**SONY**  
Broadcast

maintenance and modification information for the one-inch line of Sony Broadcast Products

model: BVH-1000A / BVH-1100A

bulletin no.: 11

Figure 2. Color Frame Flag Decoder

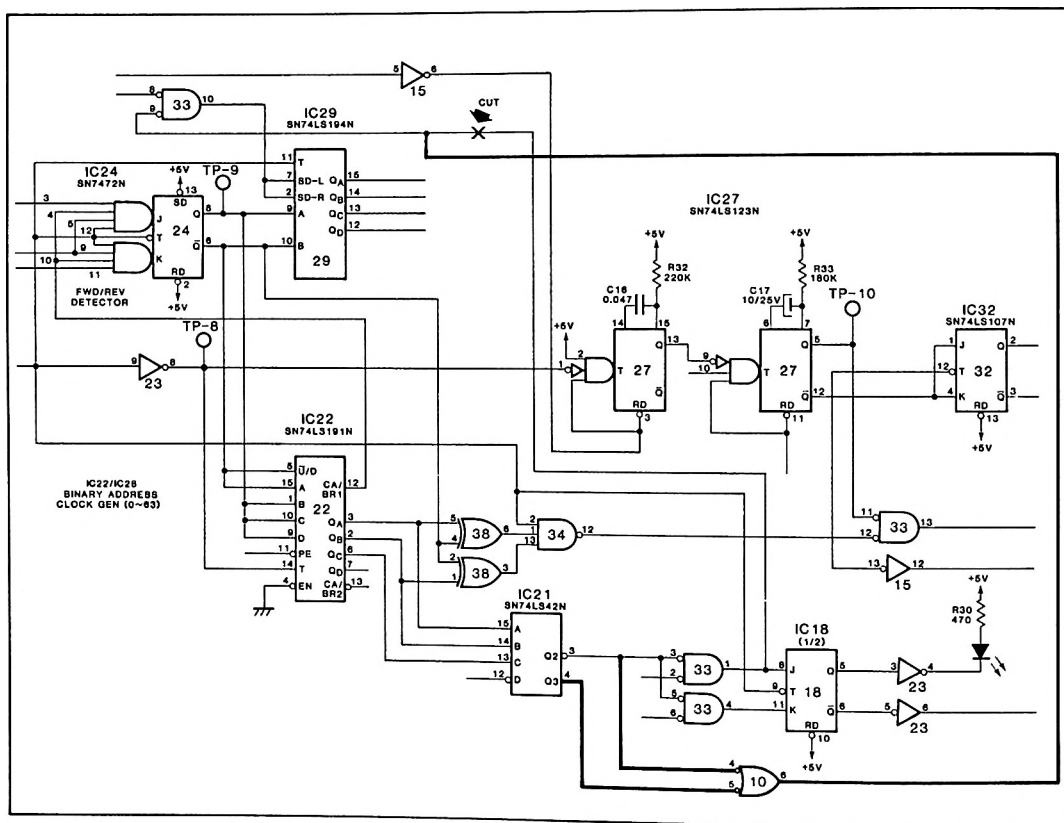
### 1. Decoding The Color Frame Flag (Figure 2)

Figure 3. Color Frame Output

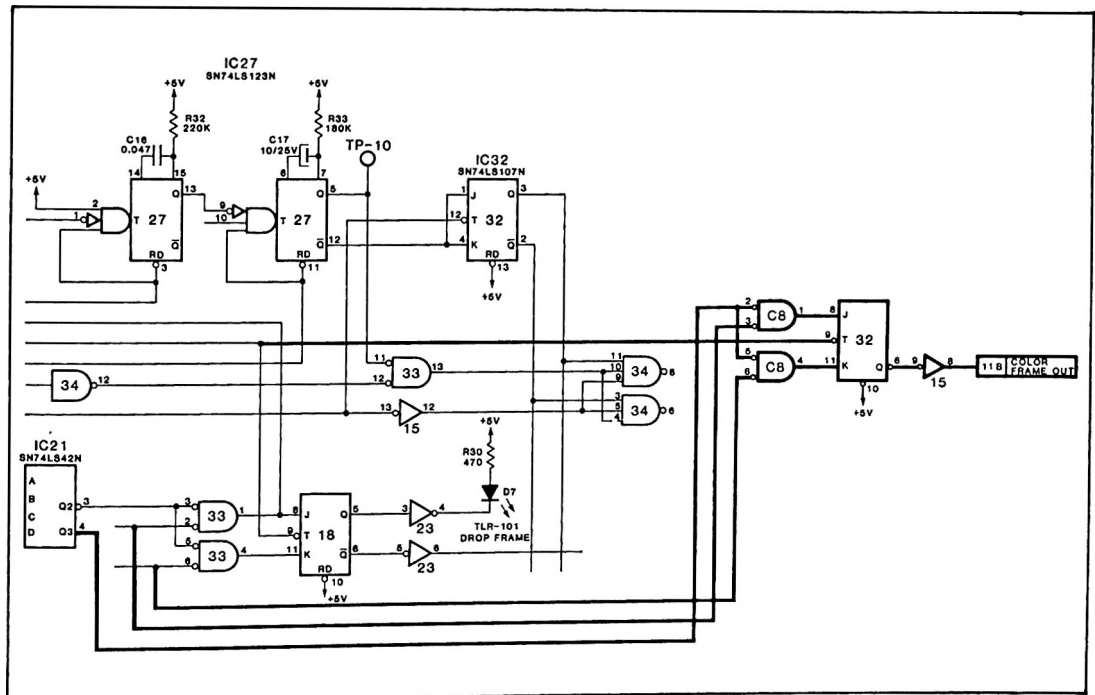
## 2. Providing The Color Frame Output (Figure 3)

Figure 1

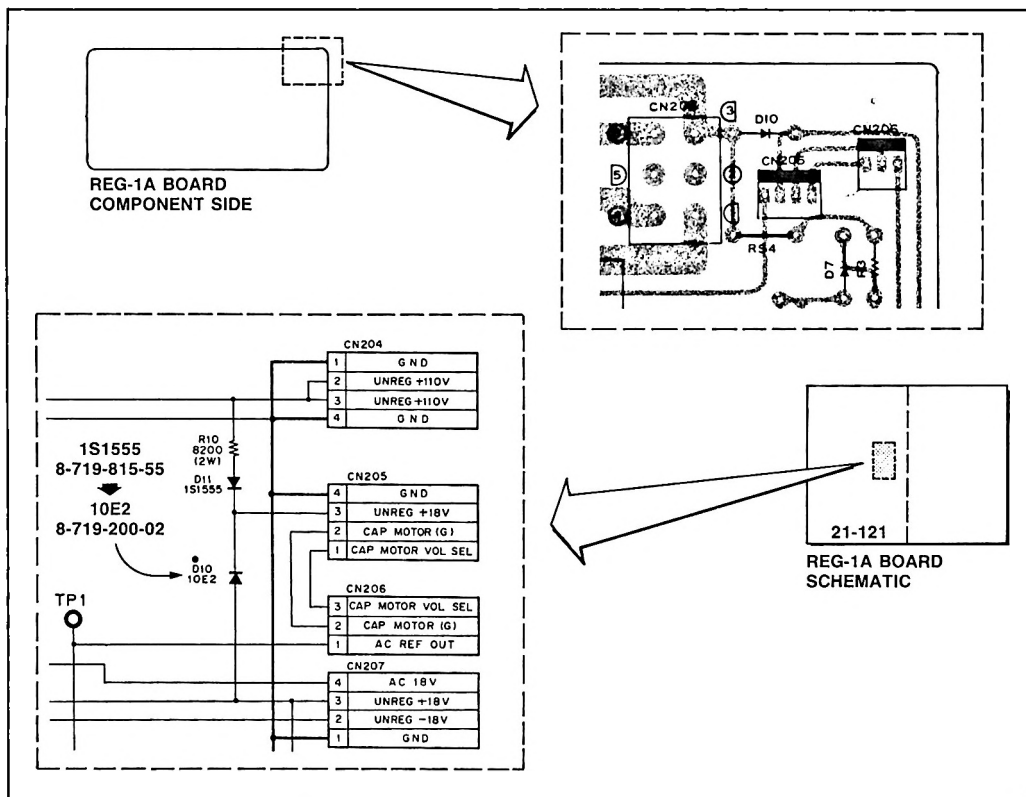
Diode D10 on the REG-1A Board has been changed in units with S.N. 20,101 and higher to increase the reverse voltage rating. This modification applied to earlier units will prevent damage should the 18V line of the Switching Regulator open.

Figure 1

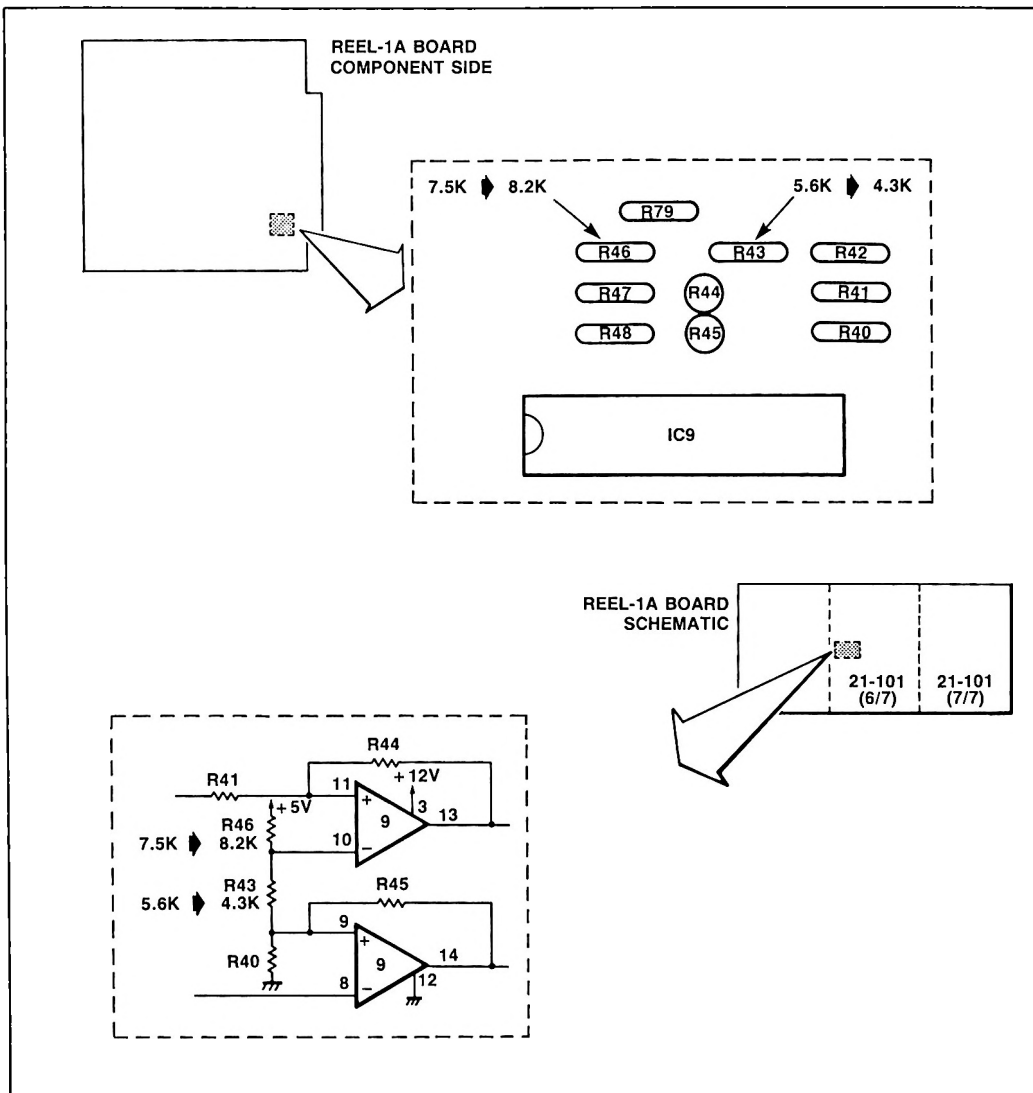
**Reel-1A Board (See Figure 1.)**

**Figure 1**

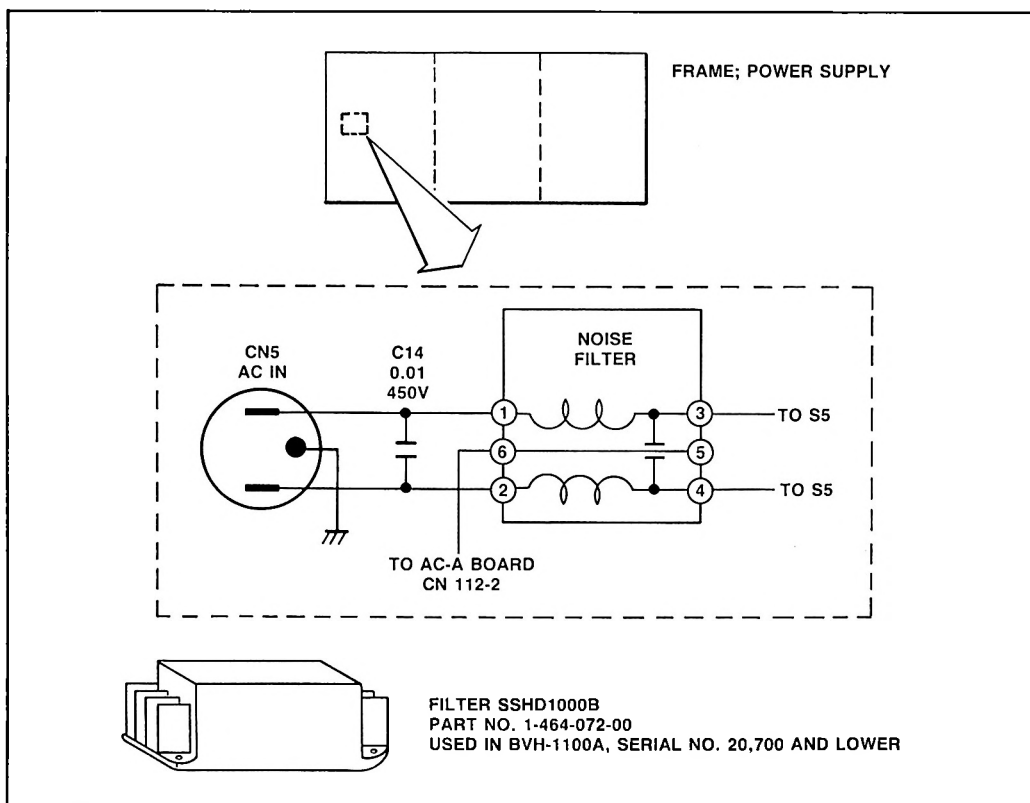
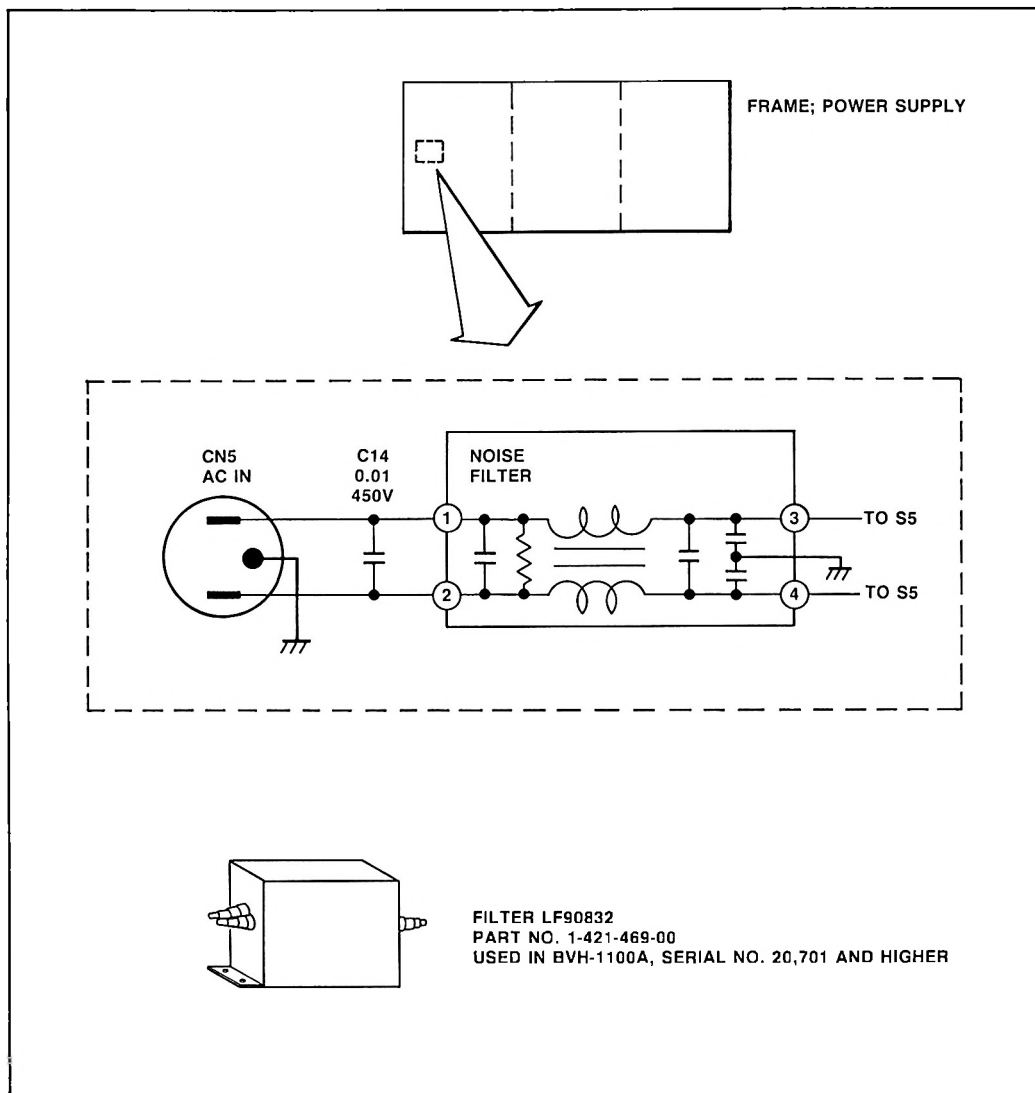
The power supply noise filter used in earlier models is not interchangeable with the filter used in later production runs. Be sure to use the appropriate part number if a replacement is needed. (See Figures 1 & 2.)

Figure 1

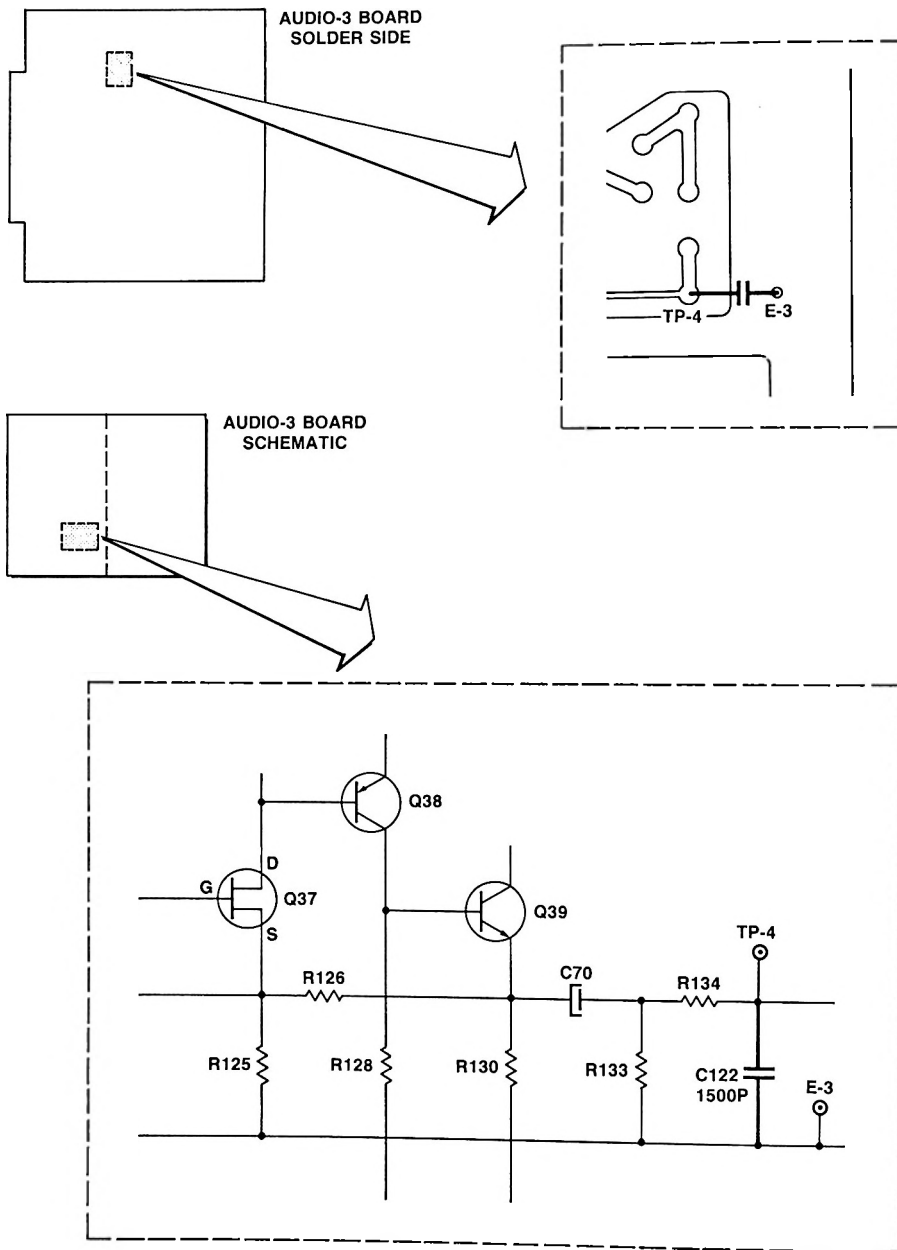
1. Connect the new capacitor (C122) between TP-4 and E-3 (Figure 1).

Figure 3

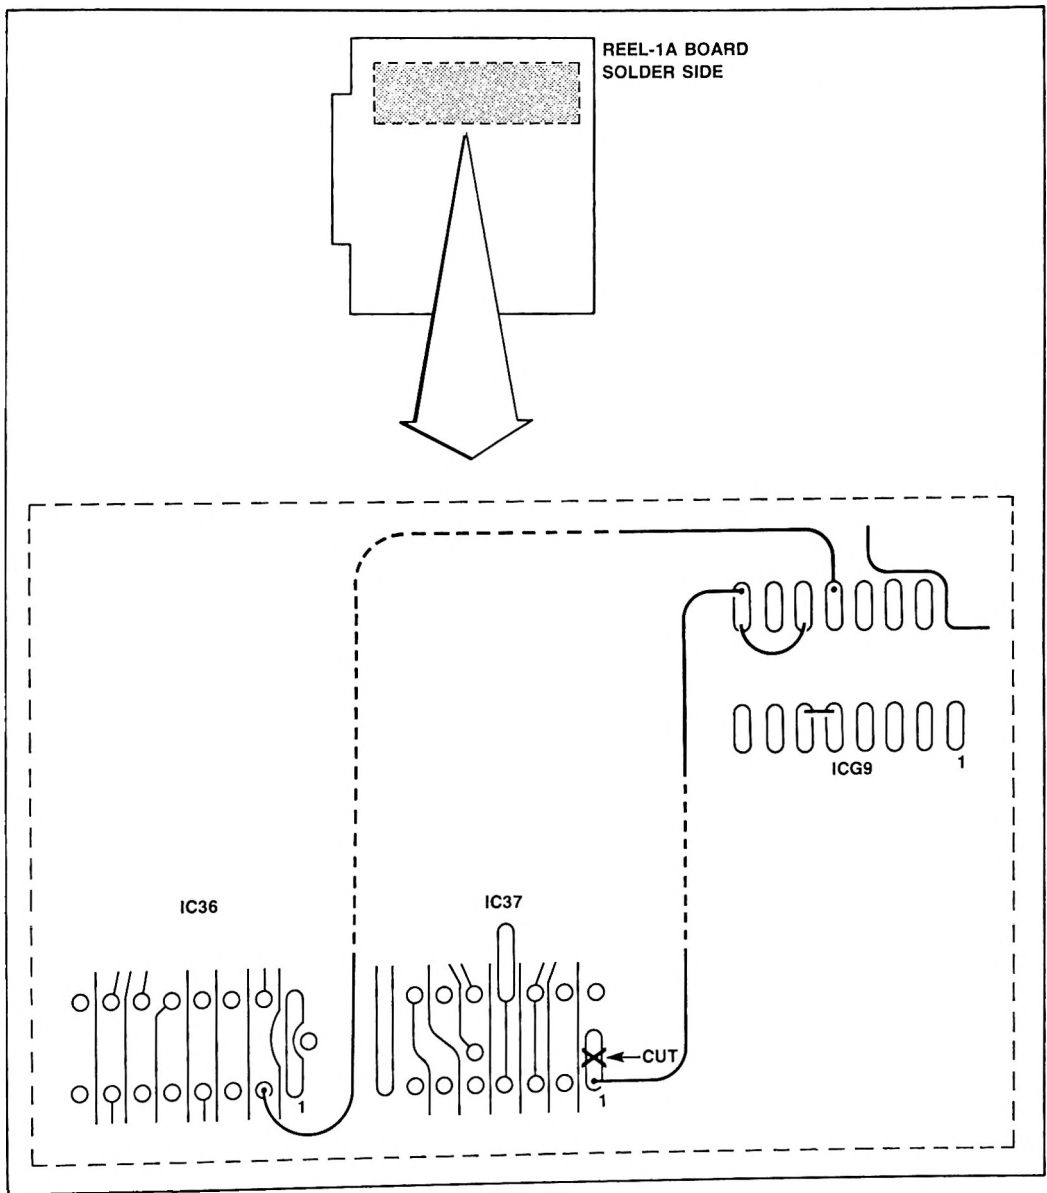
1. Add the additional circuit to the board at spare IC position G9. Insert the components as indicated in Figure 2.
2. On the solder side, add the following jumpers (See Figure 3.):

Figure 2

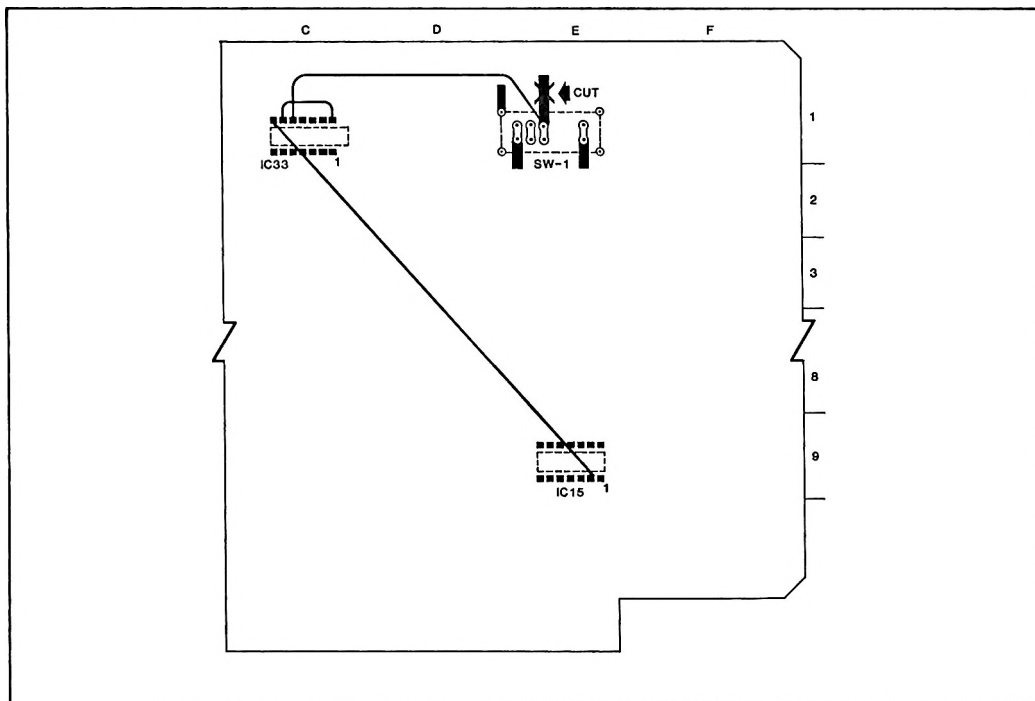
2. Cut trace between ground and pole of SW-1 as shown in Figure 2.

Figure 2

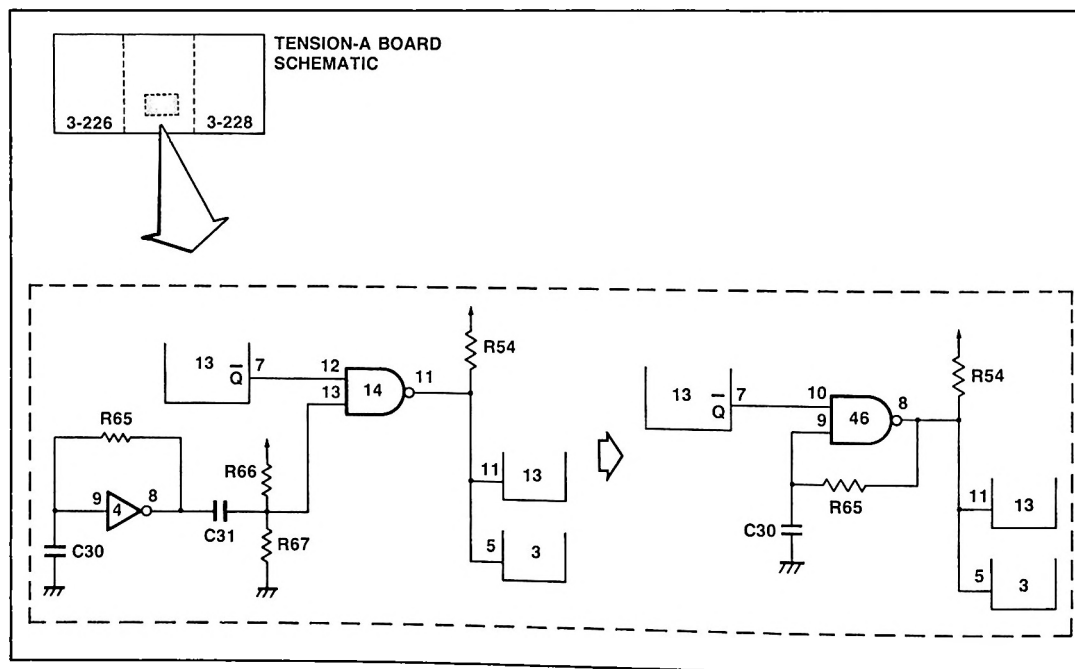
1. Delete the following components (See Figures 1 and 2.)

Figure 4

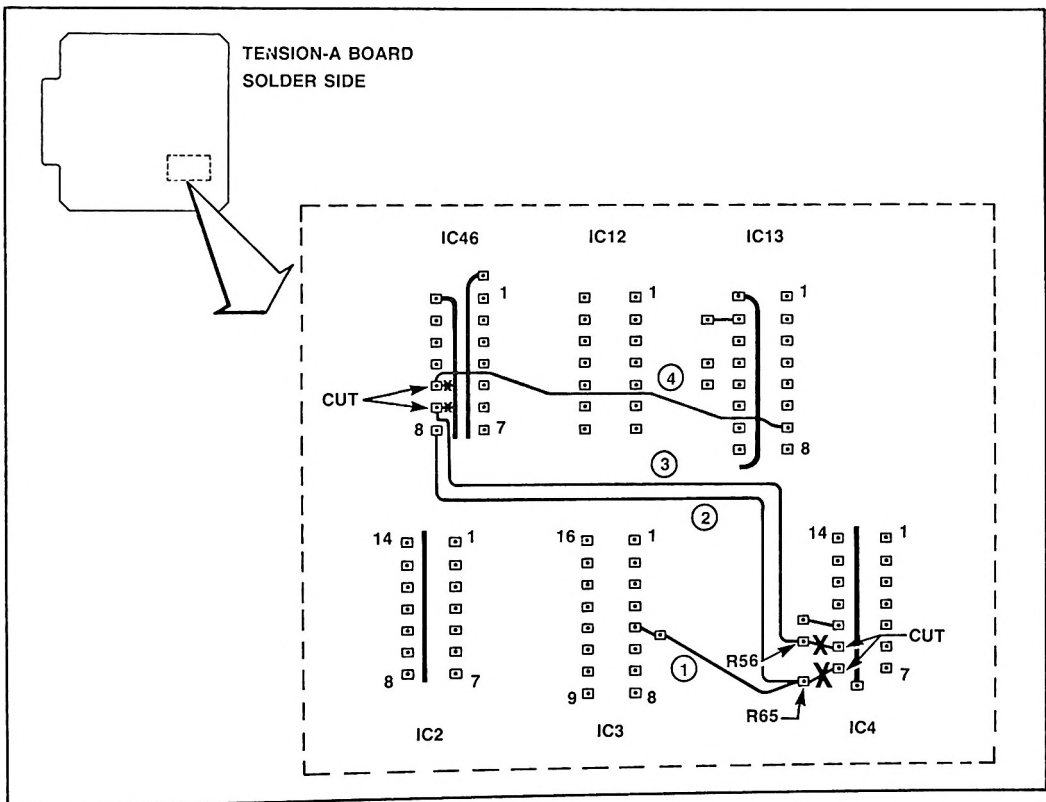
3. On solder side, cut 4 traces as shown in Figure 4.

4. On solder side, install jumpers as shown in Figure 4.

Figure 1

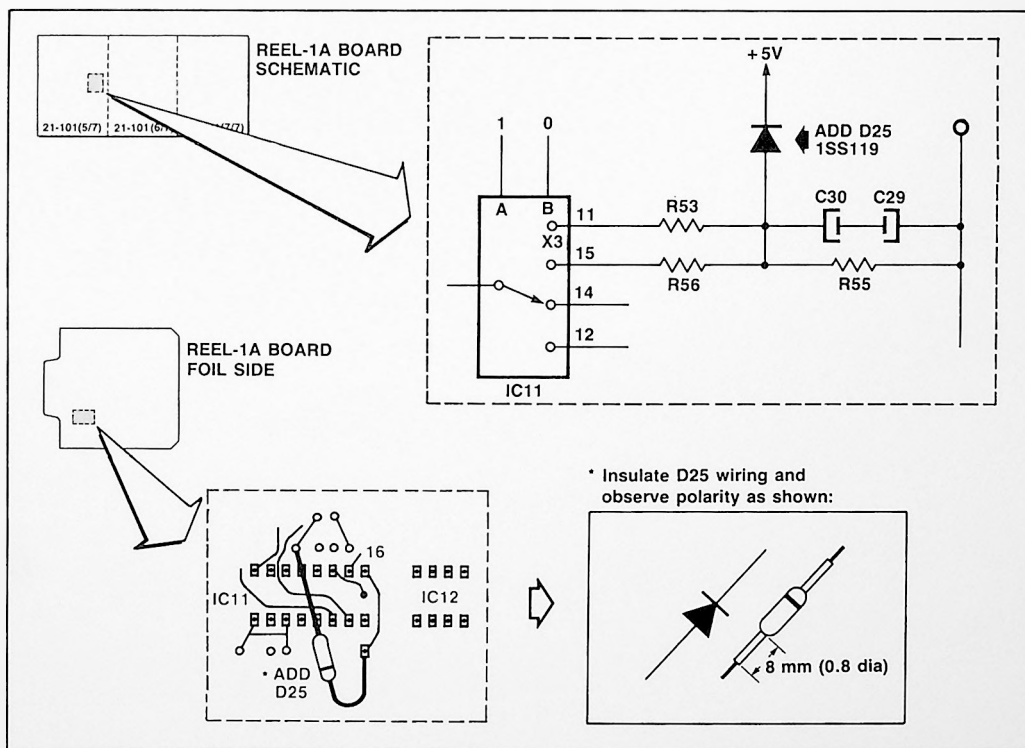
This modification provides surge protection for 4-Channel Multiplexer/Demultiplexer IC11 (TC4052) on the Reel-1A Board. The modification is factory installed in units with serial numbers 20,601 and higher. Earlier units exhibiting reliability problems with IC11 should be modified as shown in Figure 1.
